## DESIGN REVIEW COMMITTEE

SUBJECT: REVISED FINDINGS OF FACT FOR DR18-01

SUBJECT: DESIGN REVIEW REQUEST (DR18-01) BY CRAIG RIEGELNEGG ON BEHALF OF CARLETON HART ARCHITECTURE FOR HOLLANDER HOSPITALITY TO CONSTRUCT AN APPROXIMATE 29,782 SQUARE FOOT, FOUR STORY HOTEL AT 1 2<sup>nd</sup> STREET

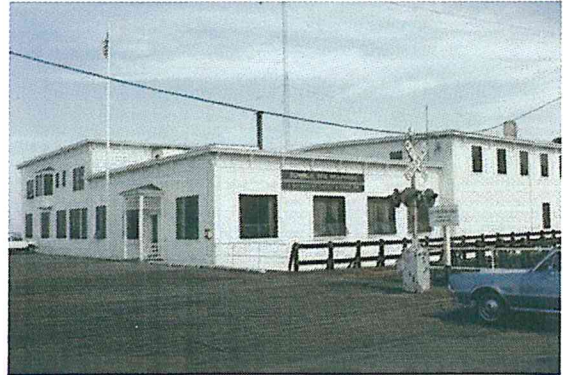
Finding The applicant notes guestroom heating and cooling units will be packaged terminal heat pumps, through wall units, that will be set in and flush with the wall. Any additional wall-mounted units elsewhere in the building shall also be mounted flush to the walls, and may not project or be visible from the right of way or Riverwalk.

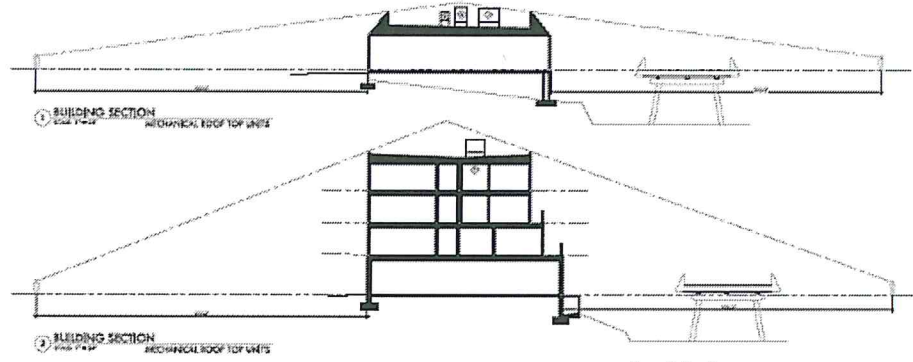
Finding: Not applicable- While the current Ship Inn façade uses cedar shakes as a cladding, the applicant included a picture of an earlier iteration of the building with a different siding material. No information was provided to clarify if the original building material is under the cedar currently in place.

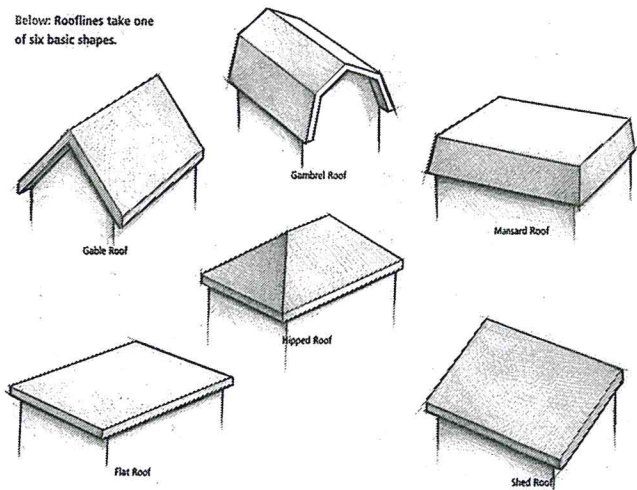
Finding The applicant proposed recladding the Ship Inn with cedar shakes that will weather to a similar appearance. Cedar is an appropriate material for the existing building. The main building would be finished with a synthetic wood material (samples were provided by the applicant at the DRC and HLC meetings). Staff has suggested an alternative to the white façade, sharing concerns around the stark white color choice. The applicant noted the material is intended to look more like a historic wood cladding that might be found in a working waterfront application.

It is staff's thought that the gray alternative is an improvement from the white, which is too bright and raises concerns in its attempt to mimic the

historic wood cladding rather than creating a modern façade more appropriate for the site.

The DRC determined the exterior wall treatment was not an appropriate at the site, noting additional details to soften the façade would improve the design.

storefront glazing and entry doors

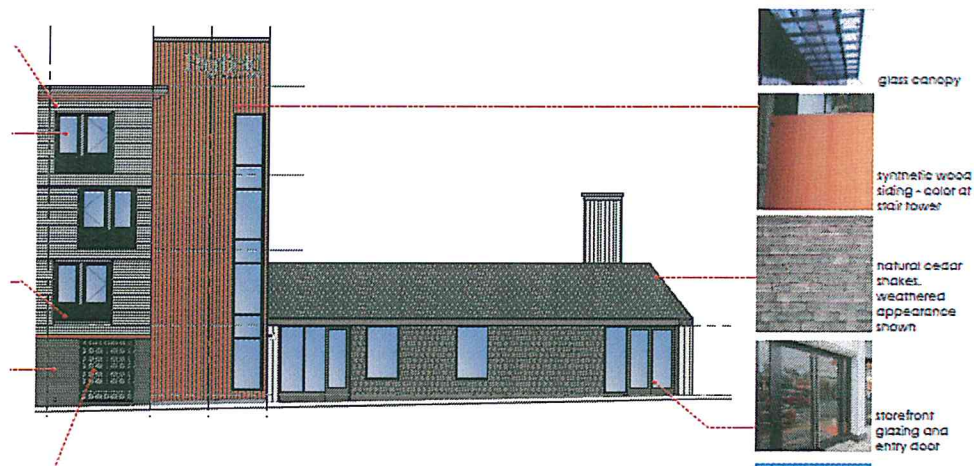
Finding: The applicant notes they changed their original proposal from automatic sliding doors to an out-swing double door on automatic controls, which will be located on the southeast and southwest entry, and are pictured below. The proposed doors are anodized aluminum frames a black and gray frames.

Finding: Doors except the emergency door on the east side are recessed. The applicant shall provide additional detailing on the emergency door which they note will be flush to the wall and finished to match. Hardware has not been detailed in the application materials. The doors incorporated into Ship Inn open have the encouraged design including operable lites on the north side of the building, but do not incorporate the same architectural features on the south side or east of the building, which are open to the street. The door design activates the north side of the building, the remaining doors do not have any special architectural detailing which is an encouraged design element. The applicant shall submit door hardware for review by the Community Development Department in order to meet criteria 14.115D4.c

Design detailing for the doors were not submitted by the applicant for review as requested. Hardware detailing was not provided for review.

fiberglass window

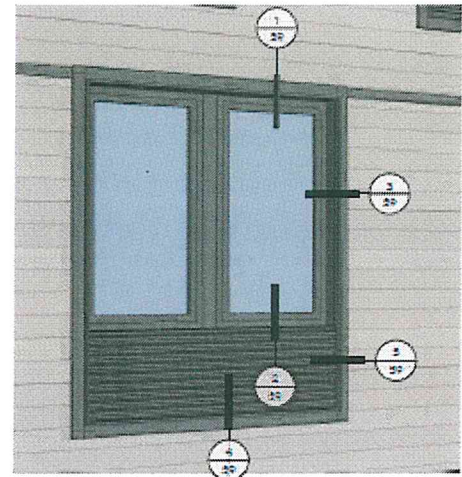
Finding: The applicant has proposed fiberglass windows on all facades. They contain casings/trim/sills and are set up higher than 18" except for the storefront glazing in common areas. The applicant shall confirm which windows contain the required crown mouldings as the sample included in the application materials noted to the right do not incorporate appropriate mouldings.

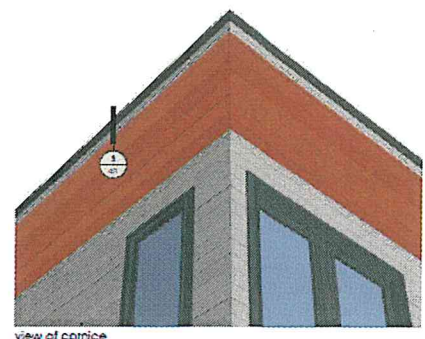
Finding: The applicant notes cedar shakes will be used on the ground floor of the existing Ship Inn Building which is proposed to be retained as a part of the development. Concrete is on the ground floor of the larger hotel building, and the proposed upper materials include a synthetic wood siding manufactured from rice hulls, attempted to reflect a weathered white paint look. A gray version of the same material has also been submitted and is more appropriate for the siding, especially because there are few other design elements breaking up the façade which incorporates this siding material as the main wall treatment.

DRC reviewed samples of proposed wall treatments provided by the applicant during the meeting, and determined the proposed wall treatment needed to be revised to better reflect the industrial working waterfront design elements the applicant noted in their design research. The proposed faux rust design did not meet criteria as a simulated product.
